ASA2 - Replace Front Seat Cushion (Passenger Side) (Recall Campaign)

Change Overview

Model Line: **Taycan (Y1A/Y1B/Y1C)**

*Installation position of seat cushion with integrated seat occupancy detection*

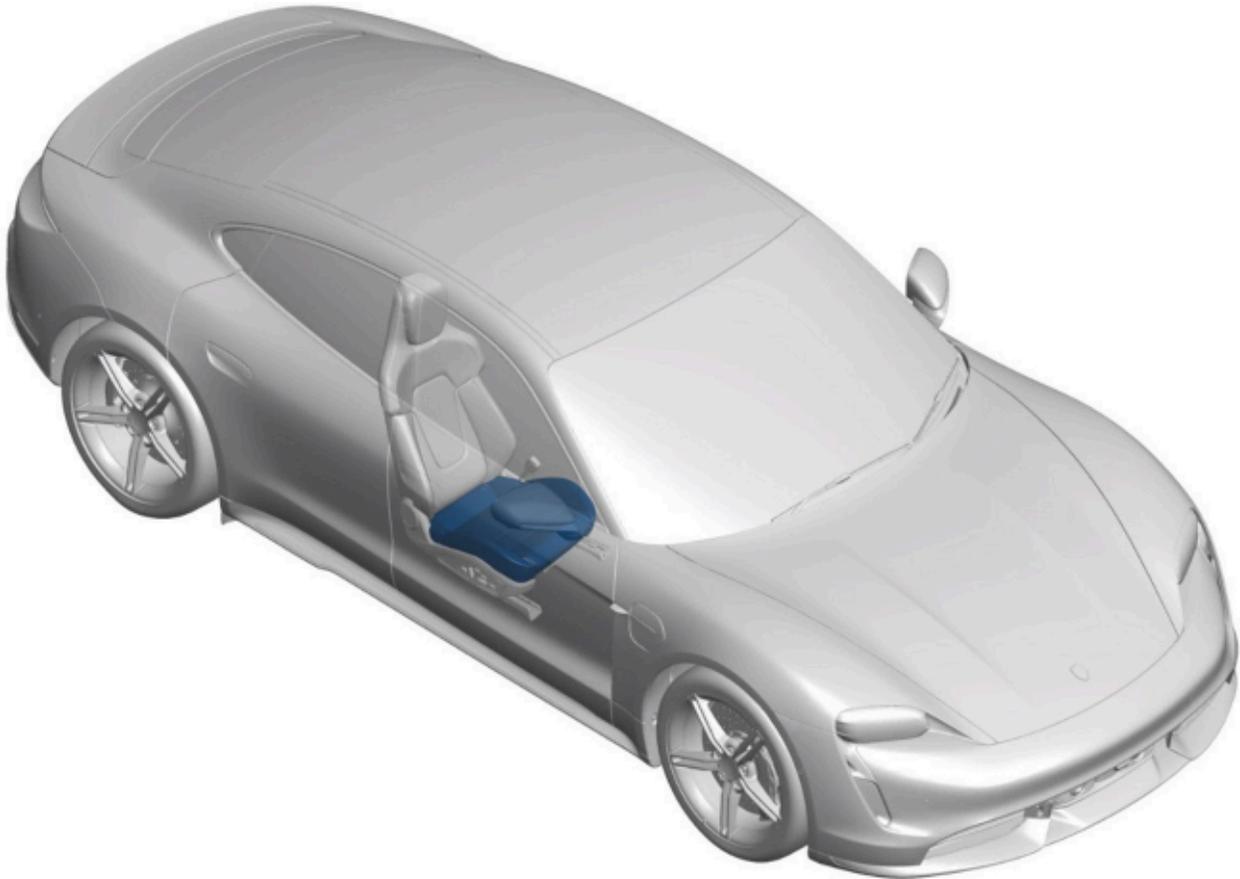
Cause: **Due to a faulty crimping connection of the seat cushion heating, the seat occupancy detection for the passenger side can activate a failsafe mode that deactivates the airbag on the passenger seat. If the activated airbag warning signal or the warning message "passenger airbag OFF" is ignored by the passenger and the passenger does not move to another seat position or leaves the vehicle, the protection of the front airbag system is not fully available to the passenger in the event of an accident. This increases the risk of injury to the passenger on the passenger seat.**

Action: Replaced the seat cushion with the integrated seat occupancy detection (passenger side).

- 4 Remove front seat cushion. ⇒ *Workshop Manual '741055A2 Replace front seat cushion'*
- 5 Install **new** seat cushion with integrated seat occupancy detection. ⇒ *Workshop Manual '741055A2 Replace front seat cushion'*
